MISSISSIPPI POWER & LIGHT COMPANY

SUBJECT: Grand Gulf Nuclear Station  
Units 1 and 2  
Docket Nos. 50-416 and 50-417  
File 0260/0862/L-340.0/L-334.0  
Transmittal of Proposed FSAR  
Changes and Responses to  
NRC Formal and Informal  
Questions  
AECM-81/345

- Attachments:
1. Question and Response 260.1
  2. Revised Question and Response 362.7
  3. HGEB SER Open Item - Ultimate Heat Sink
  4. NRC Concern - Shared Systems
  5. SER Open Item - Soil-Structure Interaction

FIGURE 2.5-75b SHEET 2 OF 2

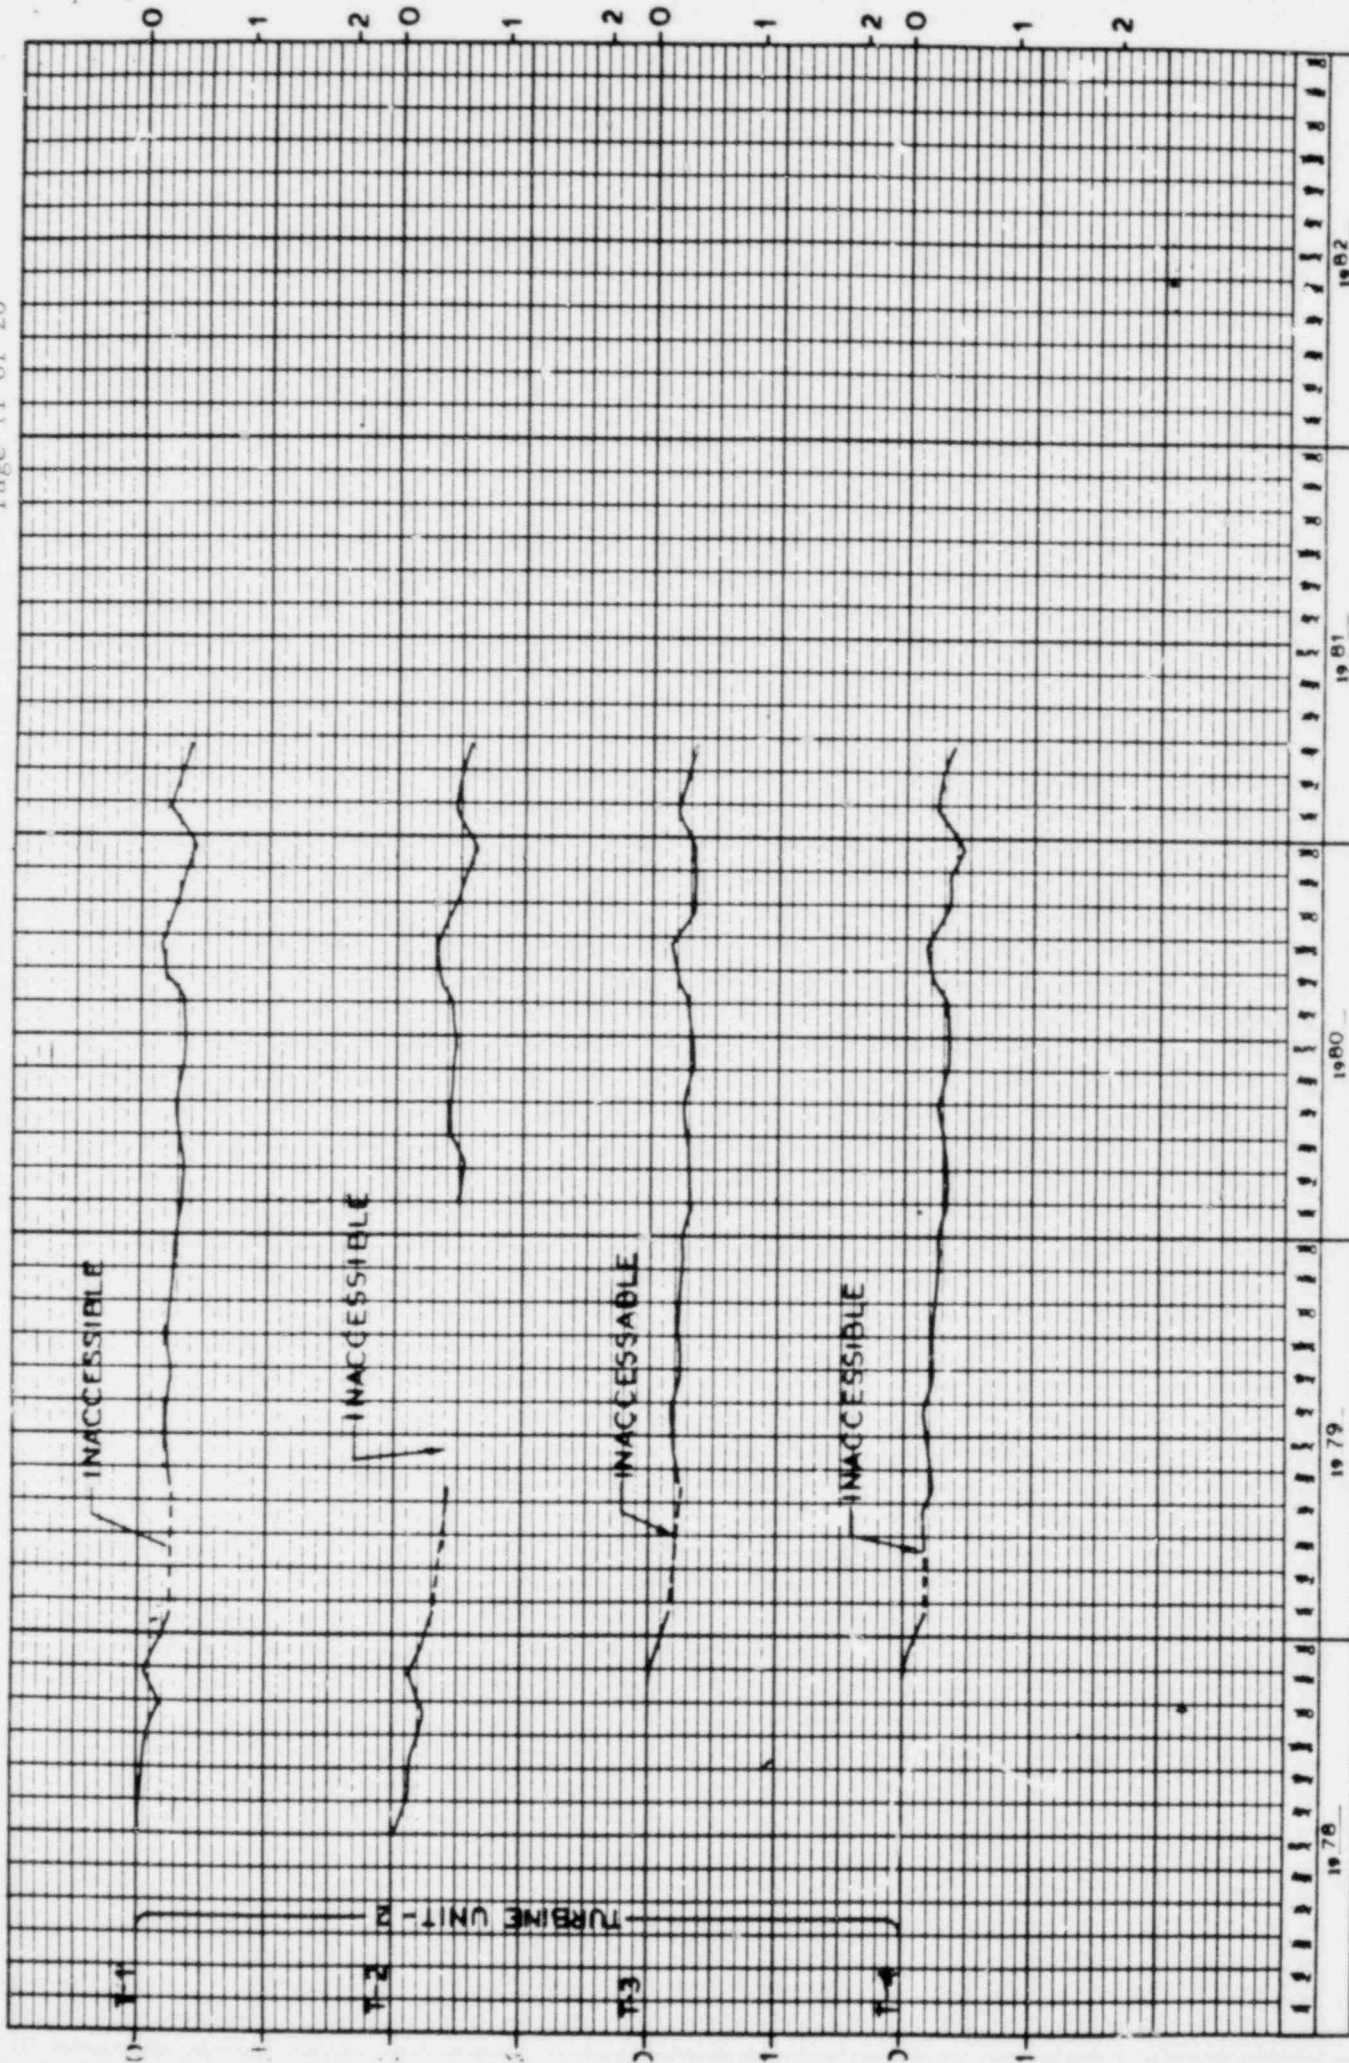
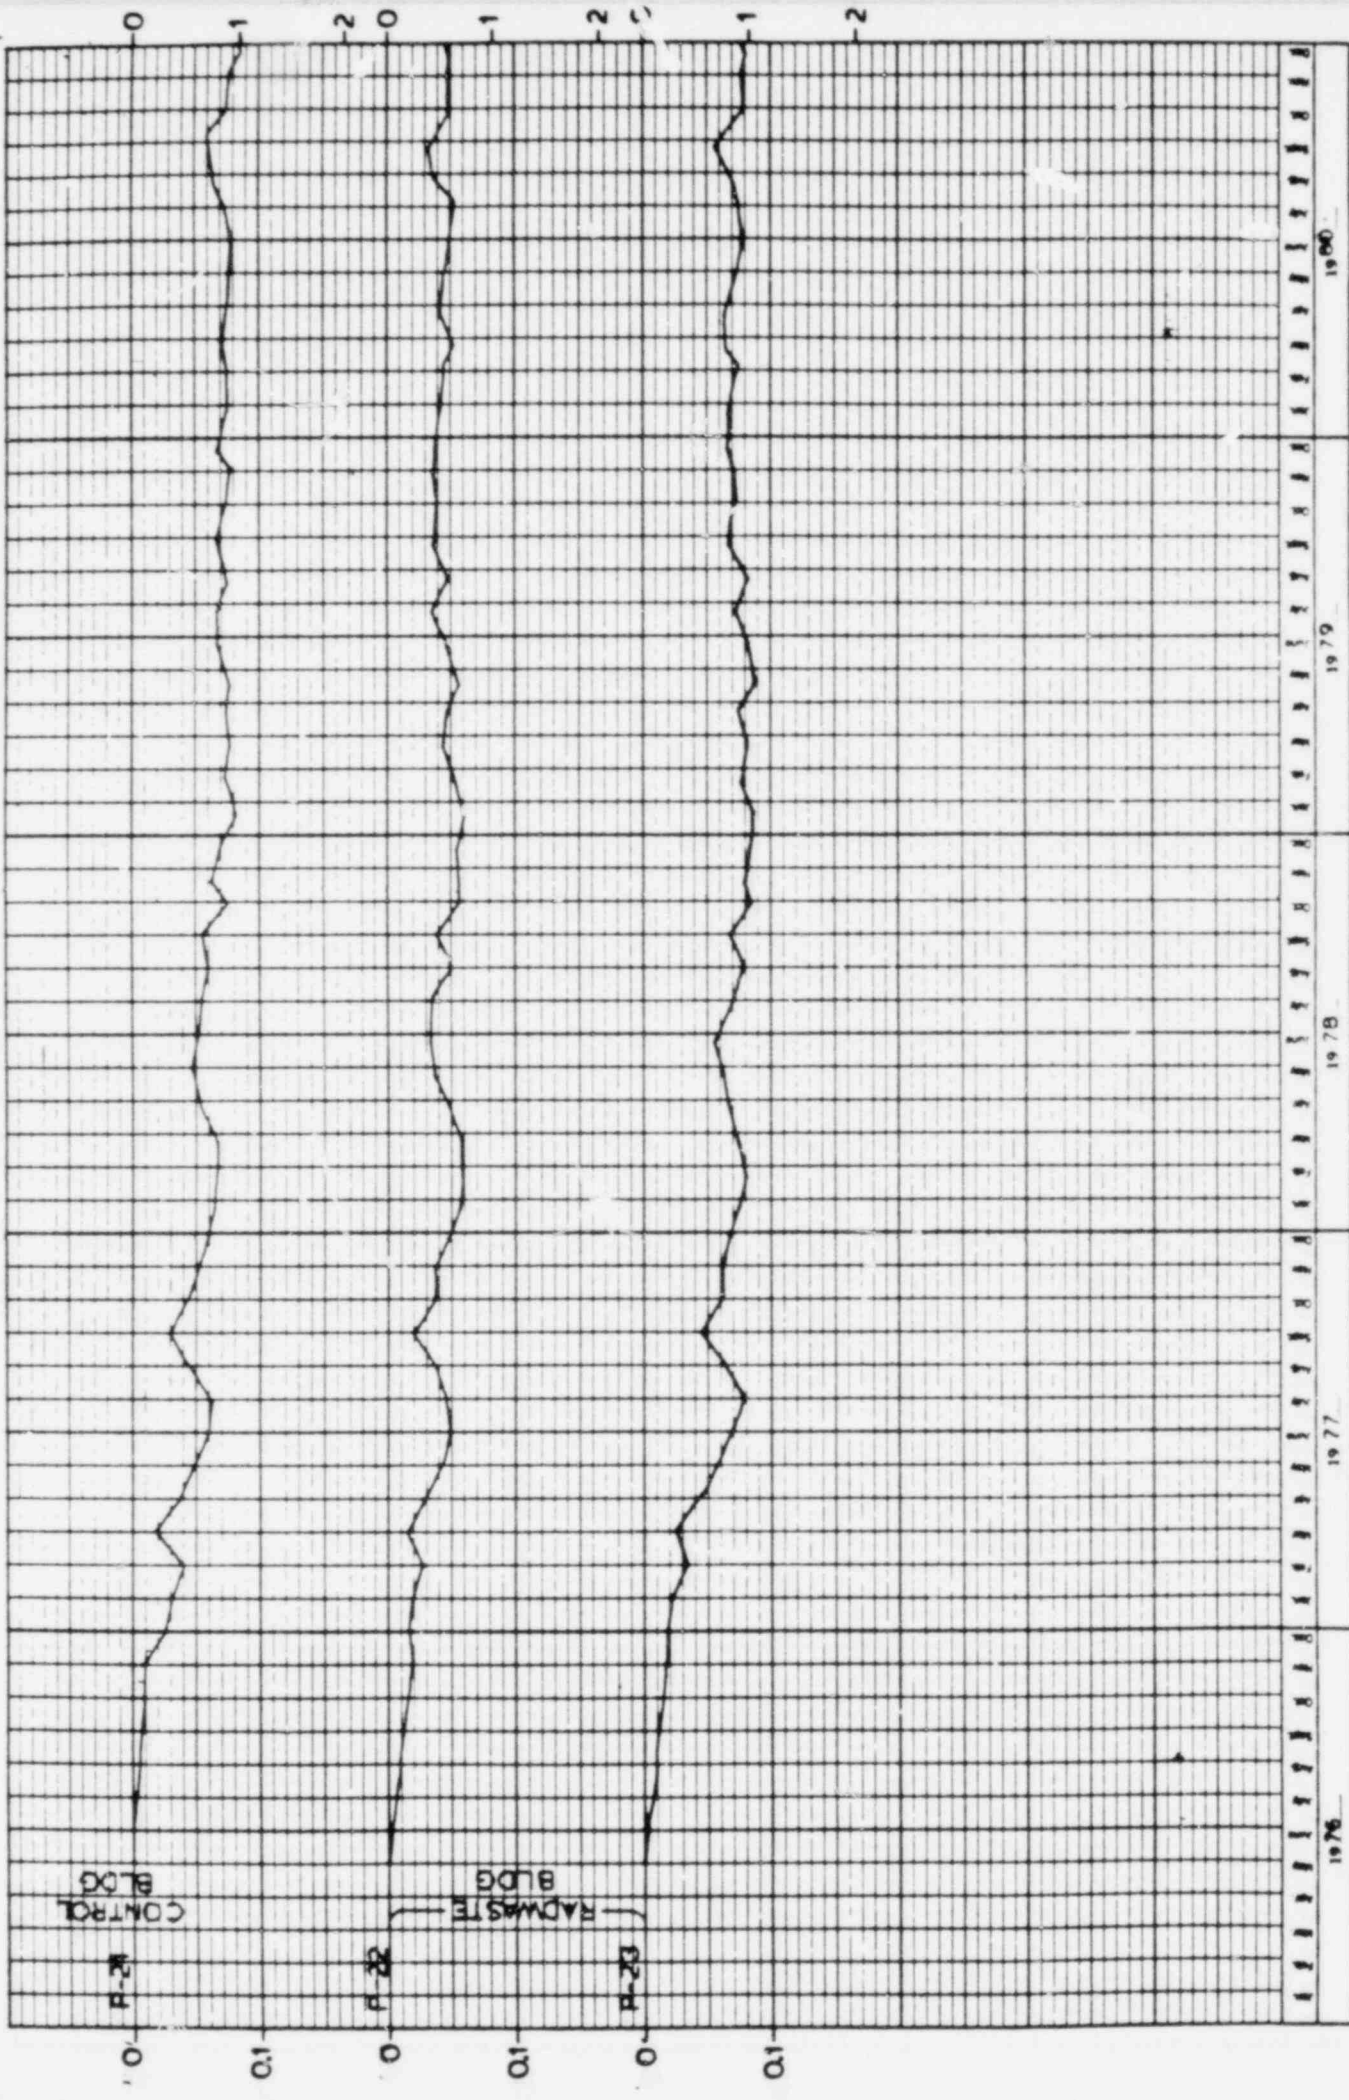
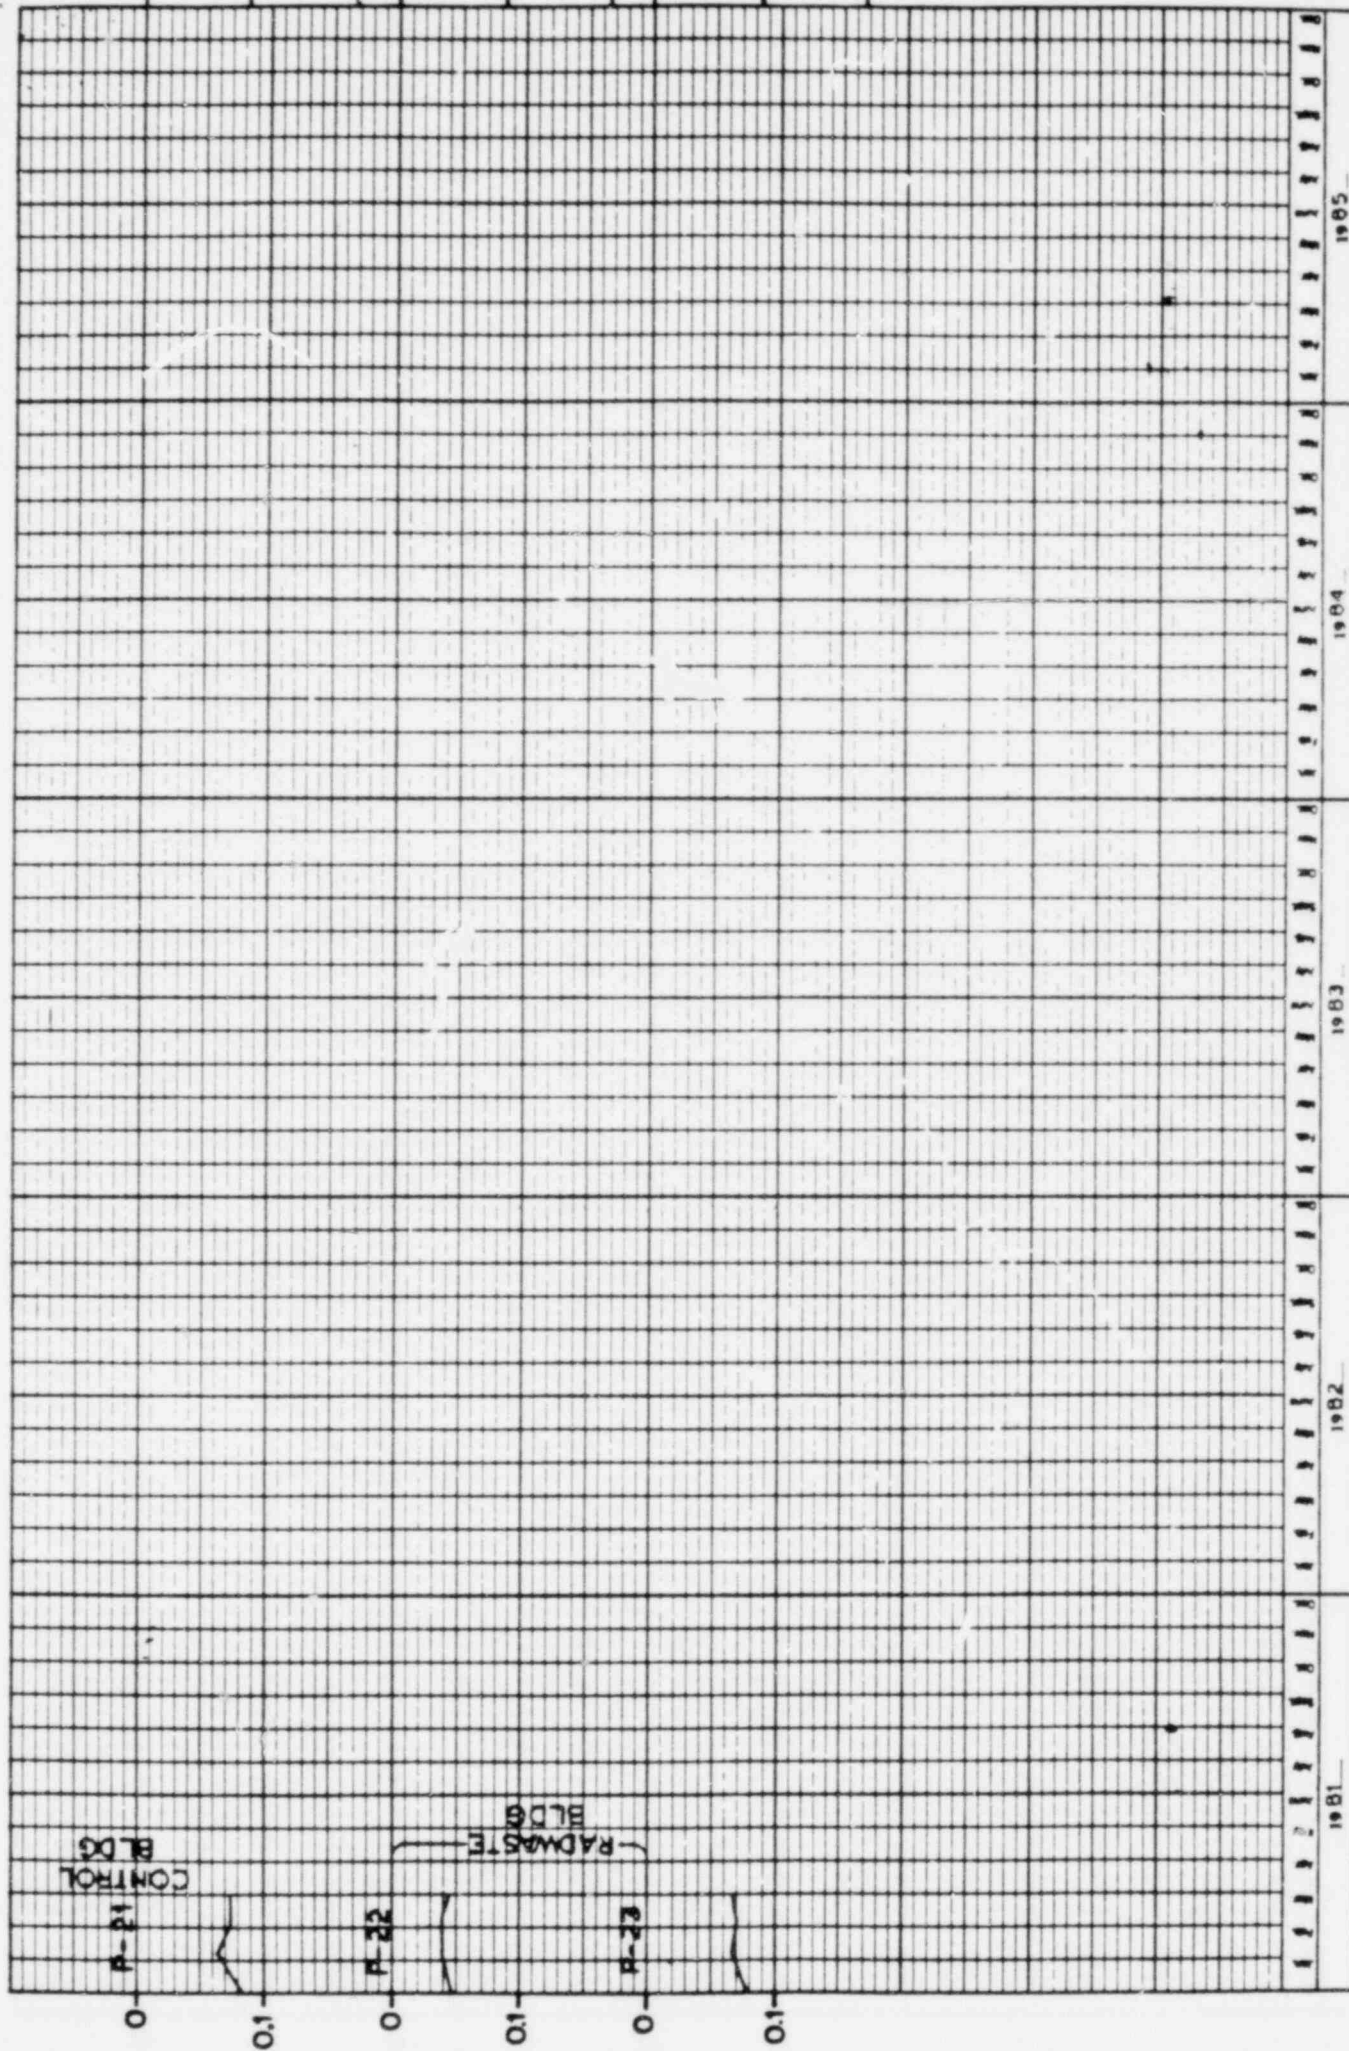
362.7 Your response to NRC Question 362.5 (page Q&R 2.5-14, Amendment 30) is not complete. Indicate what measured value of differential settlement would cause code allowable stresses to be exceeded for individual buildings and buried piping and require notification of NRC. Provide a table of these values and the limiting stress criteria. Update the plots which show settlement recorded to date versus time; this is particularly important since construction of Unit 2 was still underway when your response to Question 362.5 was being developed.

The response to this question is given in revised subsection 2.5.4.13.1, revised Table 2.5-10, and revised Figures 2.5-75a through 2.5-75h.

The settlement markers will be read at one-month intervals until construction is complete and all pools are filled with water, at which time the results of the settlement monitoring program will be evaluated and long-term monitoring of the structures will be assessed. Total settlement will not be a Geotechnical concern until the following measured values are observed:

Turbine building	3"
Radwaste building	3"
Control building	3"
Containment building	3.5"
Auxiliary building	3.5"
Diesel generator building	3"
